Subj: FISCAL YEAR 2023 NAVSEA STANDARD ITEMS CHANGE 2

## Summary of Change FY23 CH-2

**Summary of FY-23 Changes to Standard Item 009-32,**  
**“Cleaning and Painting Requirements; accomplish”**  
**and Associated Technical Rationale for Each Change**

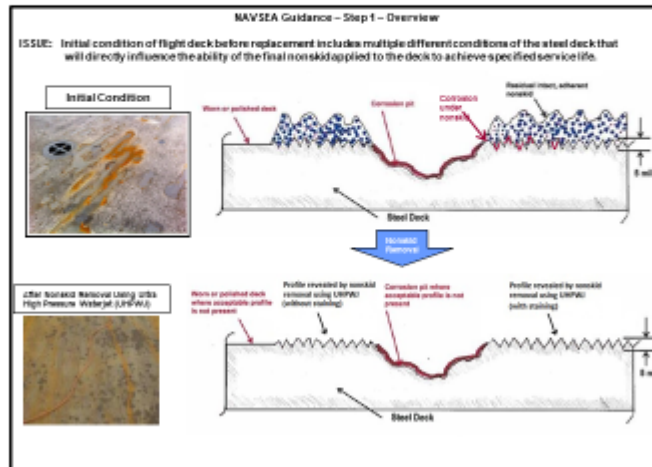
**47. CHANGE:** Aligned surface profile requirements by incorporating maximum surface profile requirements:

Added a maximum profile of 4 mils in paragraph 3.10.5.2 in the FY-23 update to Standard Item 009-32 for areas following power tool cleaning to SSPC-SP 11 or SSPC-SP 15. Added a maximum profile of 6 mils in paragraph 3.11.4.1 in the FY-23 update to Standard Item 009-32 for nonskid areas where the surface is prepared to SSPC-SP 11 due to the inability of abrasive blast equipment or waterjet equipment to access such areas.

**RATIONALE:** During nonskid replacement work on an LHD in 2016, NAVSEA received reports of surface “profiles” that were far in excess of any surface profile that could be created using conventional surface preparation processes. Rather, the reported profiles were associated with the deckplate QA/QC staff mis-reporting on an inherently rough surface (i.e., due to corrosion or pitting) and simply reporting that number as “profile.” To address this issue, NAVSEA included a requirement to abrasive blast 20% of the flight deck to the FY-18, Change 1, Standard Item 009-32 (i.e., published on 07 Mar 2017). The rationale for the 2017 change was that areas with pitting and corrosion are required to be abrasive blasted to create surface profile rather than simply reporting on a measurement of a pitted or corroded surface as “profile.” The following slides explain this issue:

### Standard Item 009-32 – Sketches Showing Best Practices

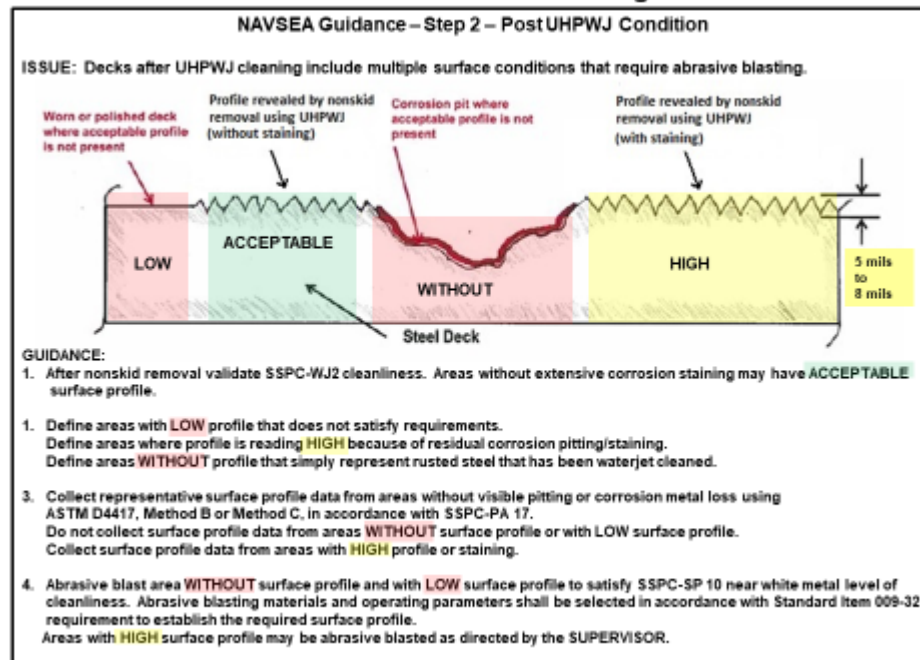
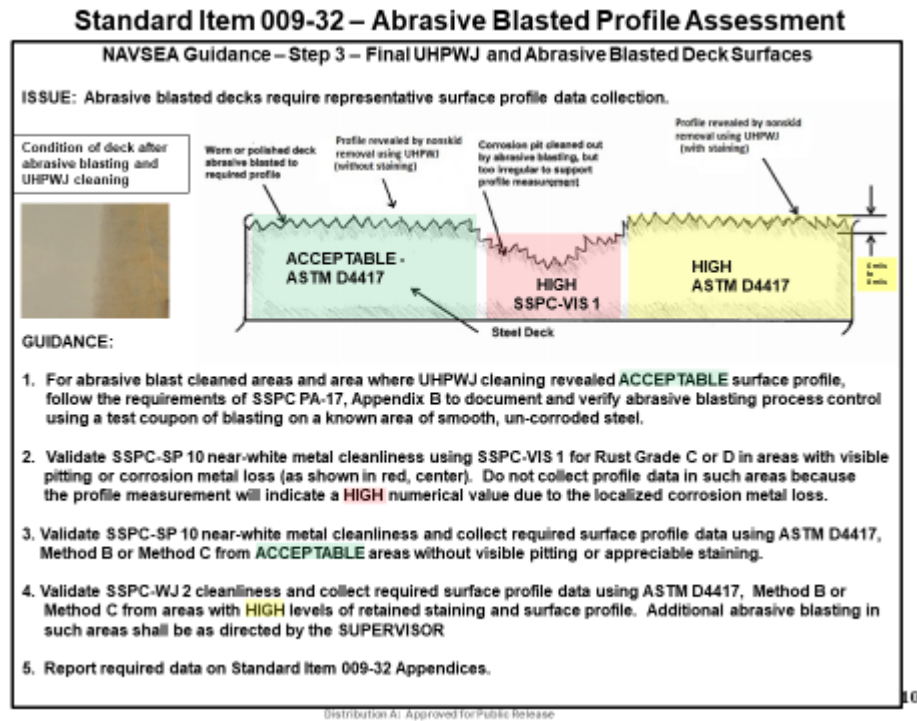
Given that background, the SUPSHIP NNS proposal is intended to establish limits on maximum profile to prevent similar cases of the coating applicators reporting on corroded or pitted surfaces as having levels of “profile” above those that could be created by power tools in accordance with the SSPC-SP 11 or SSPC-SP 15 normal work practices. This the change will avoid confusion on the waterfront regarding profile reporting and will ensure that the deckplate QA/QC staff understand that the concepts described in the slides above that discuss abrasive blasting also apply to power tool cleaned surfaces. Thus, the change will require deckplate QA/QC staff to collect representative data on the profile created by the power tool and not simply report on rough or pitted steel as “profile.” Because the change addresses an improper data reporting practice, the proposal will not appreciably alter workmanship practices or job costs. However, the change will reduce the time engineering has to expend addressing “profile” data that is generated incorrectly from rough or corroded surfaces.
